**THE SCHOOL DISTRICT OF PHILADELPHIA
Office of Capital Programs
440 North Broad Street, 3rd Floor – Suite 371
Philadelphia, PA 19130**

Addendum No. 3

Subject: Delaplaine McDaniel Elementary School
2022 Classroom Modernization
SDP Contract Nos. 2022-009-G, 2022-009-E

This Addendum No. 3, dated FEBRUARY 18, 2022, shall modify and become part of the proposed Contract Documents of the work of this project. Any items not mentioned herein, or affected by, shall be performed strictly in accordance with the original Contract Documents, unless modified by prior addenda.

**DRAWING NO.
E102**

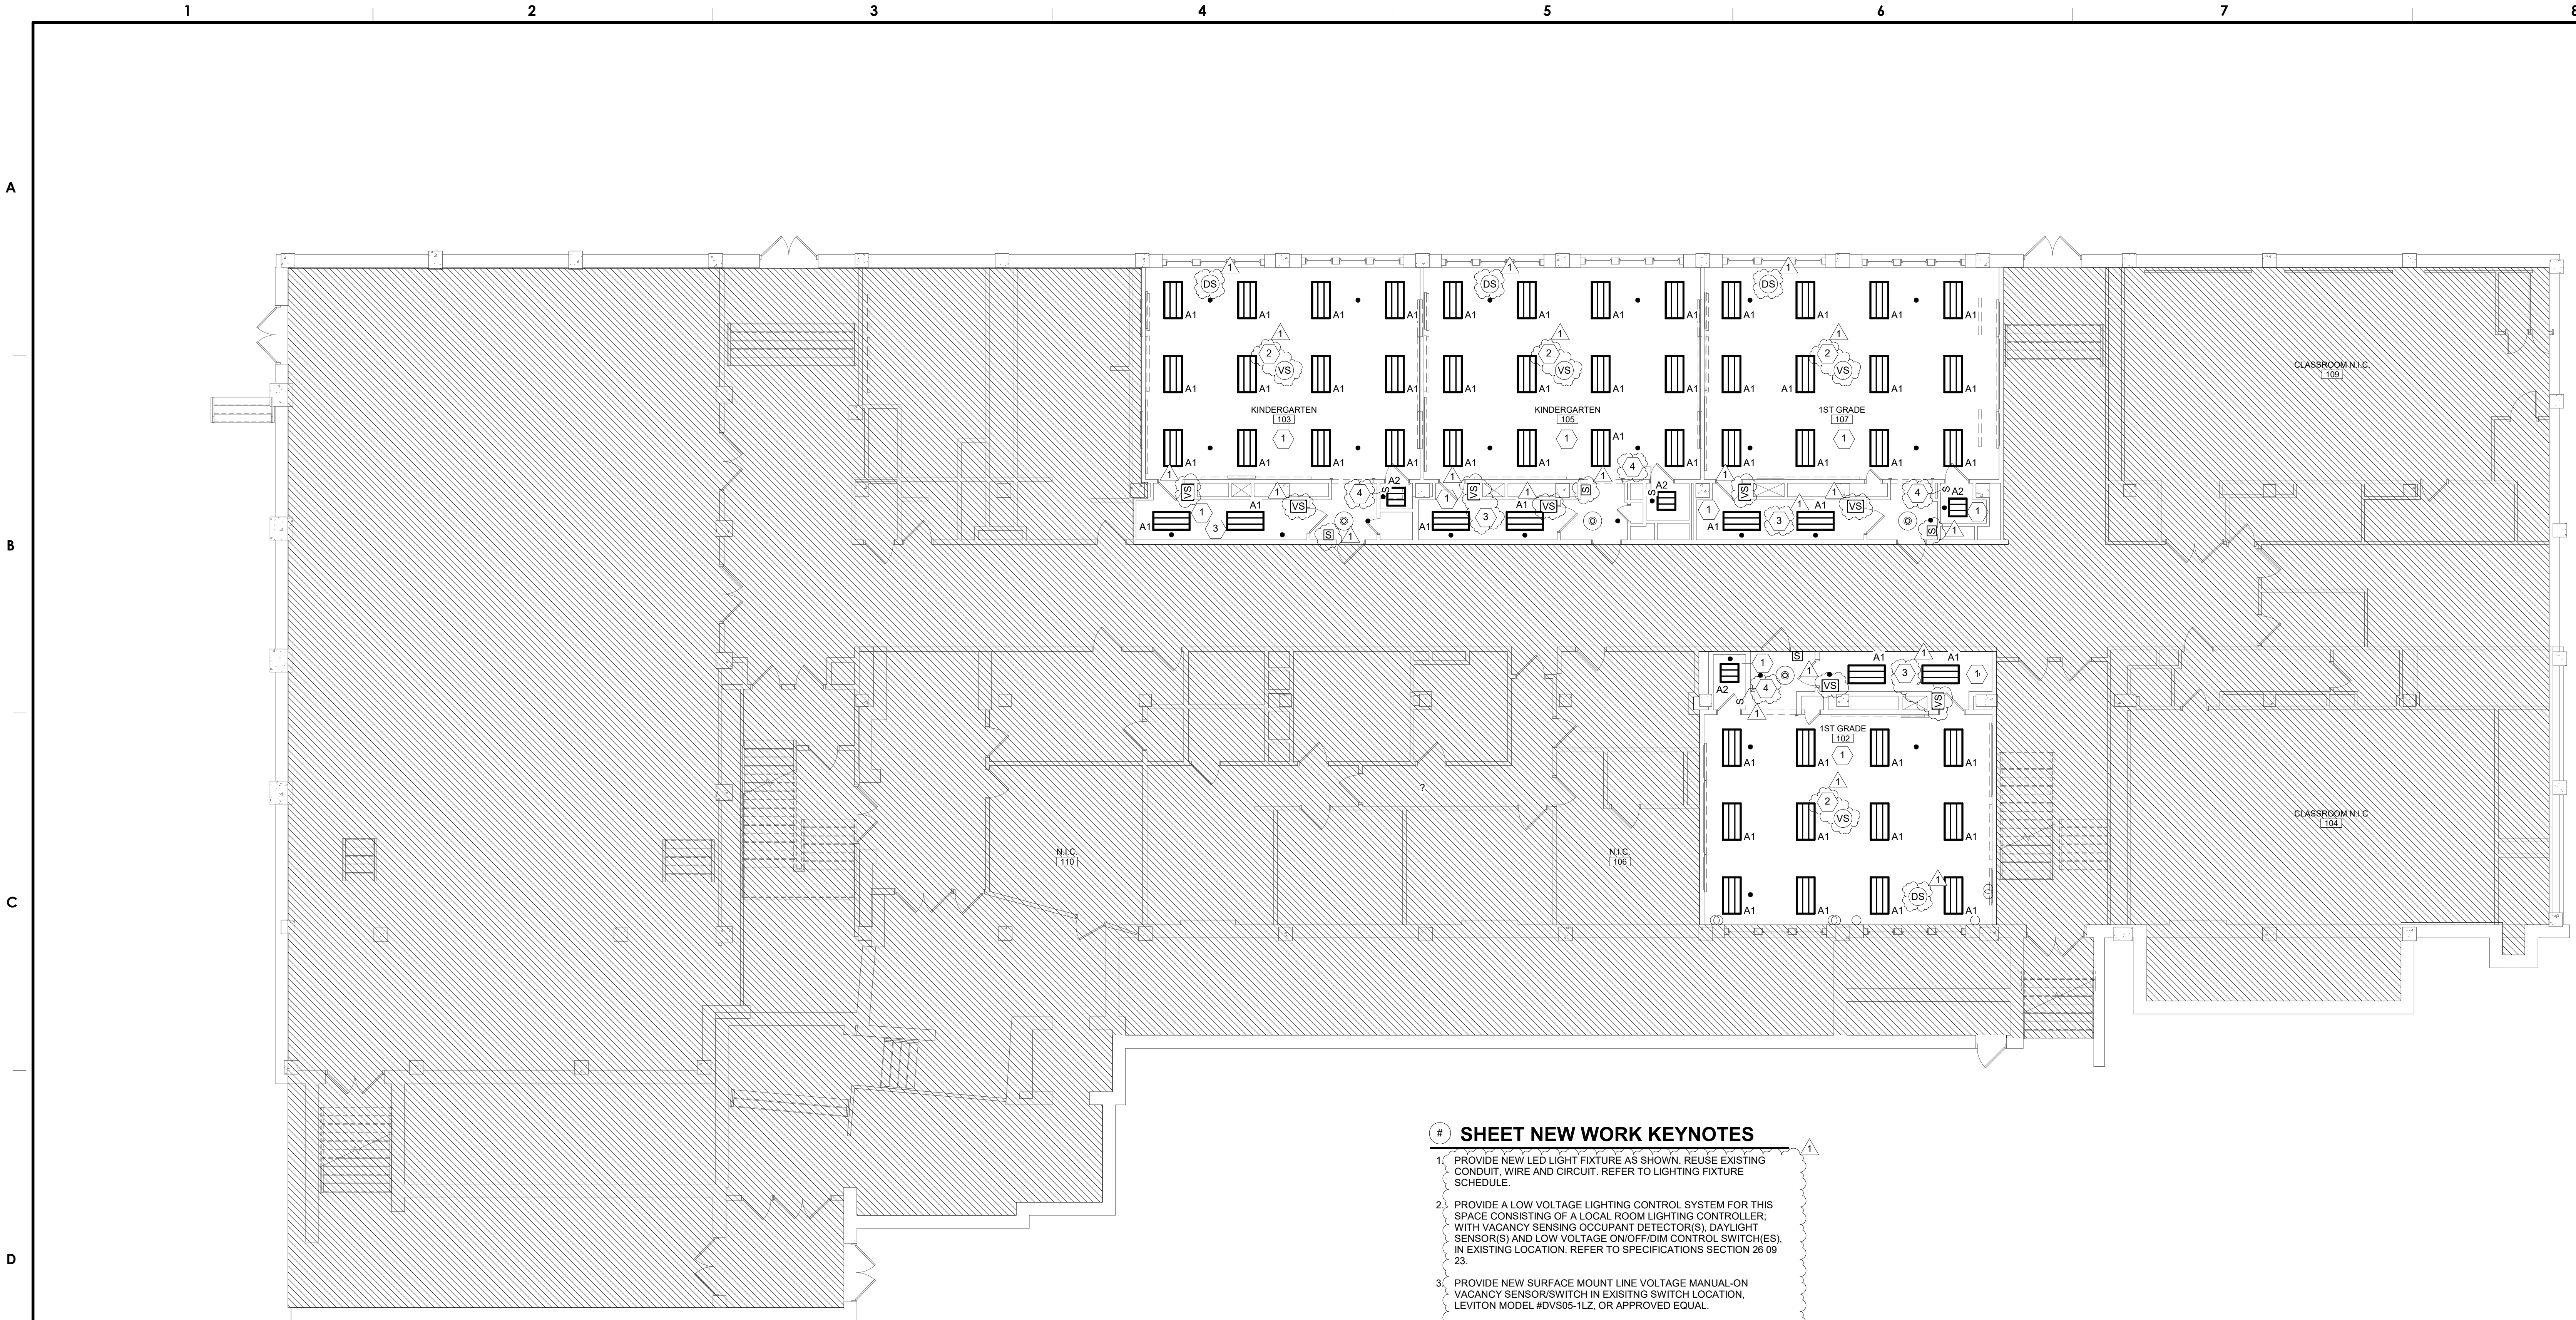
5. **Question:** Ref: Drawings E100, E101, E102, E103 SHEET KEYNOTE #3 - How do we bid "Provide new data outlets & Cat 6 cabling as needed"?

6. **Question:** Ref: Drawings E100, E101, E102, E103 SHEET KEYNOTE #3 - Does each classroom have the Cat 6 cabling required for the quantity of drops?

7. **Question:** Ref: Drawings E100, E101, E102, E103 SHEET KEYNOTE #3 - What is the location in the buildings for the MDF?

9. **Question:** Ref: Drawings E100, E101, E102, E103 SHEET KEYNOTE #7 - "Provide new clock if existing is in working condition." Should we bid to replace clock only if it is in working condition?

10. **Question:** Ref: Drawings E100, E101, E102, E103 SHEET KEYNOTE #7 - What type clock (battery, 120 volt, 24 volt) & quantity should we bid to replace? Are you requiring a systems clock (Sapling) or an off the shelf unit?

16. **Question:** Division 27 specs were not provided. Please confirm CAT6 cable should be provided for new voice drops, new data drops, and new WAP drops. Please confirm CAT6 should be run on j-hooks above drop ceilings, and in EMT when exposed.

Response: Refer to sheet keynote 3 on revised E101 and E102 attached.

Response: Refer to sheet keynote 3 on revised E101 and E102 attached.

Response: Refer to locations shown on revised E101 and E102 attached.

Response: Provide new clock - refer to keynote 8 on revised E101 and E102 attached.

Response: Clocks are to be Sapling, hardwired. Refer to specification section 275313 attached.

Response: Existing wiring to be reused in new conduit and outlets. Refer to keynotes 1, 2, 3 on revised E101 and E102 attached. Provide CAT6 for all new work, refer to spec section 271300 Communications Systems attached.

**DRAWING NO.
E201**

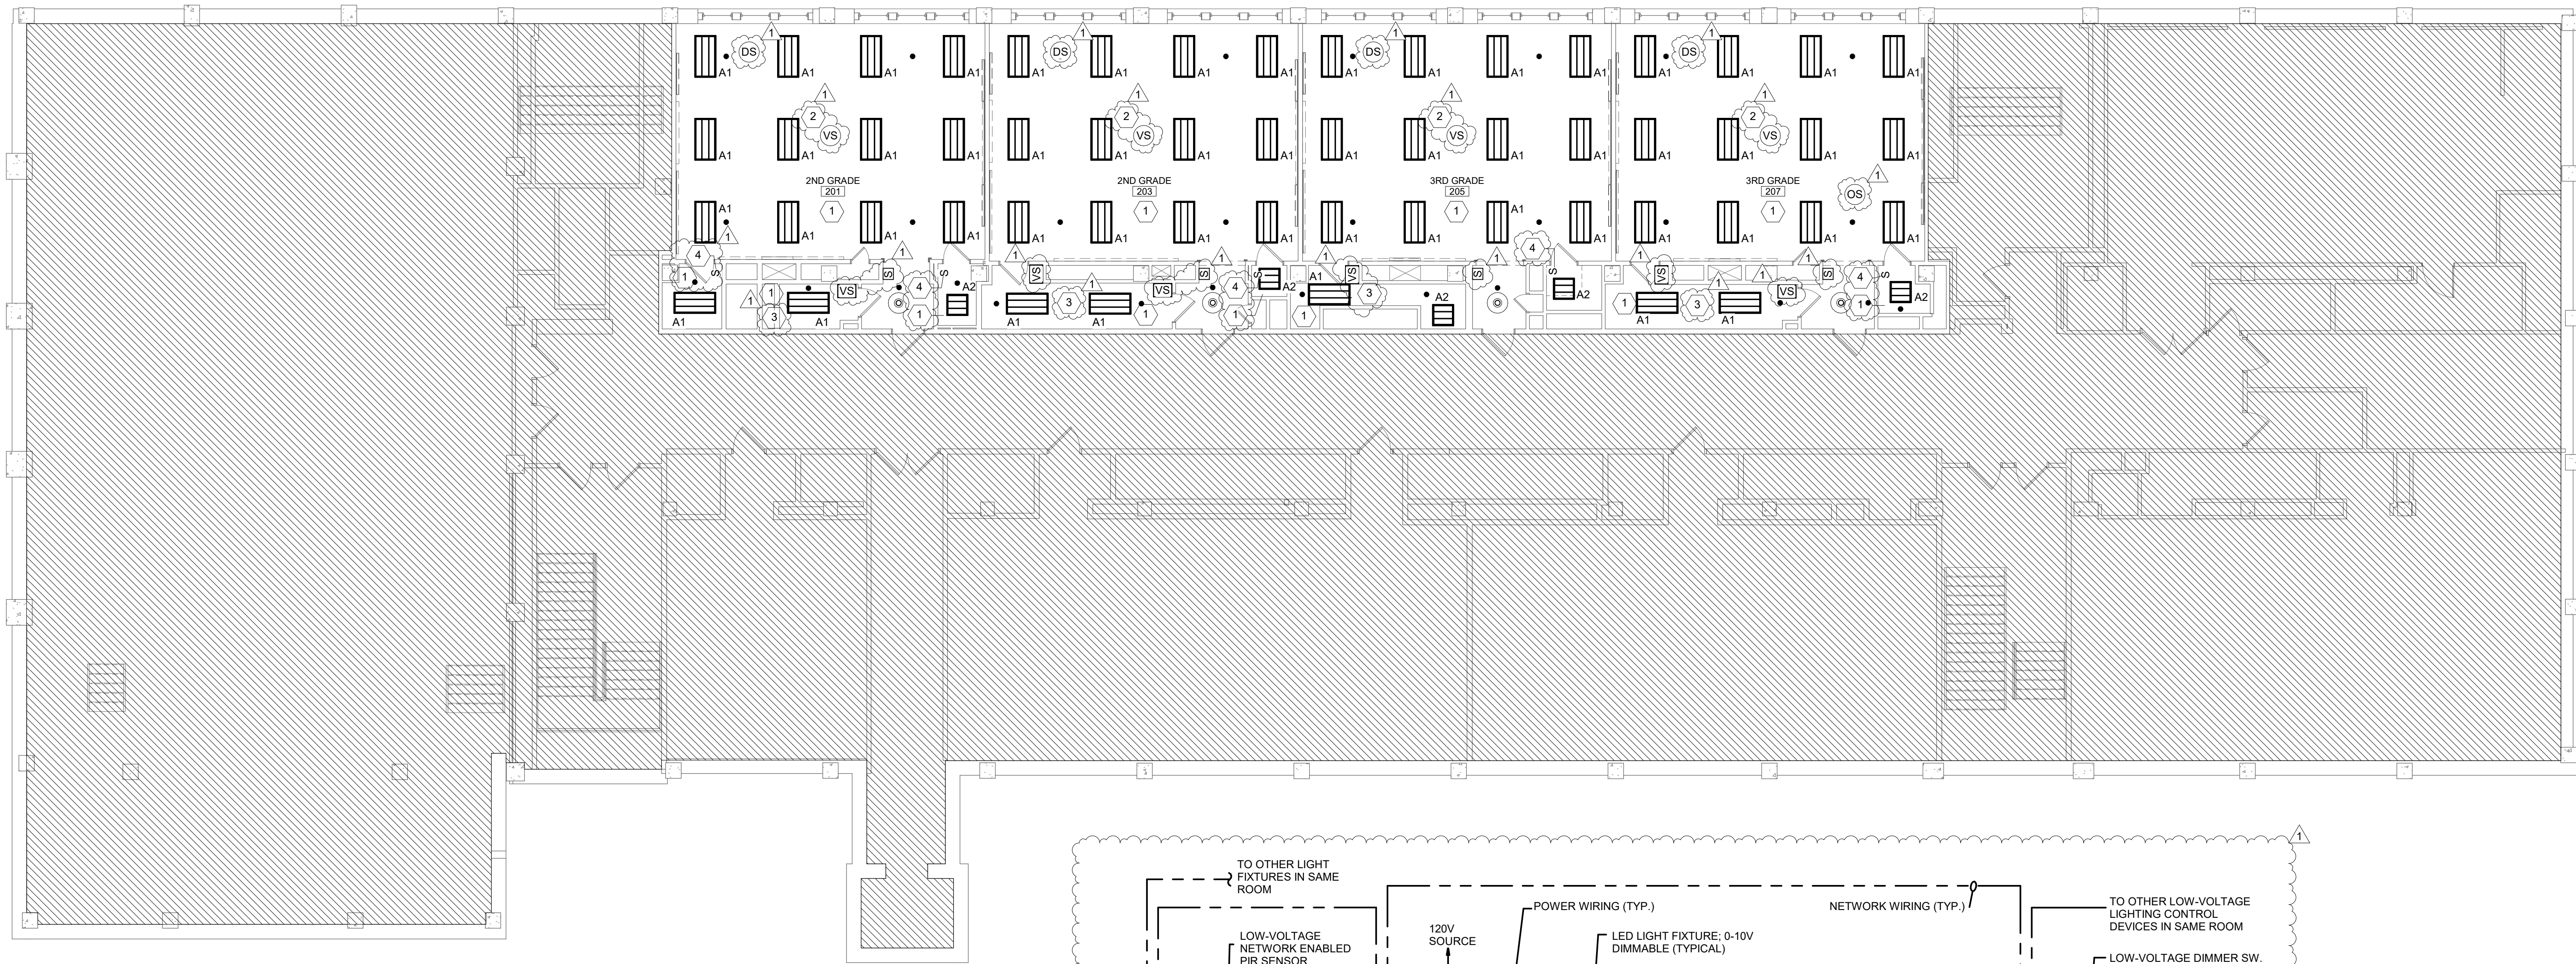
11. **Question:** Drawings E201, E202 keynote #1 calls for dimming lighting controls in the classrooms but the note has very little detail on design requirements. The floor plans show nothing in terms of design for the lighting controls (control layout, zoning, basis of design part numbers etc.). The floor plans conflict with keynote #1 and show single pole switches which do not dim. Why was a design not provided with basis of design control part numbers like all other typical SDP projects? If no design will be provided, please answer questions below.

- a. Are the dimming controls in the classroom supposed to be low voltage digital (room controller type)?

- b. Is there supposed to be 2 control zones, (1) for the row of lighting adjacent to the window and (1) for the other (2) rows of lights? Or are there 3 control zones for each of the 3 rows?

- c. Are the storage closets associated with each classroom supposed to have some sort of analog automatic control (e.g. PIR wall mounted line voltage occ sensors)? If so please specify requirements as toggle switches are currently shown.

13. **Question:** Fixture type A3 is specified on drawing E201, but there are no instances of type A3 shown in plan. Please confirm type A3 is not in scope. If type A3 is in scope, please clarify the following:

Response: Refer to revised E201 and E201 drawings attached.

Response: Refer to locations, keynotes, and wiring diagram shown on revised E201 and E202 drawings attached.

Response: Refer to locations and keynotes shown on revised E201 and E202 attached.

Response: Refer to locations and keynotes shown on revised E201 and E202 attached.

Response: Fixture type A3 is removed from the schedule on revised E201 attached.
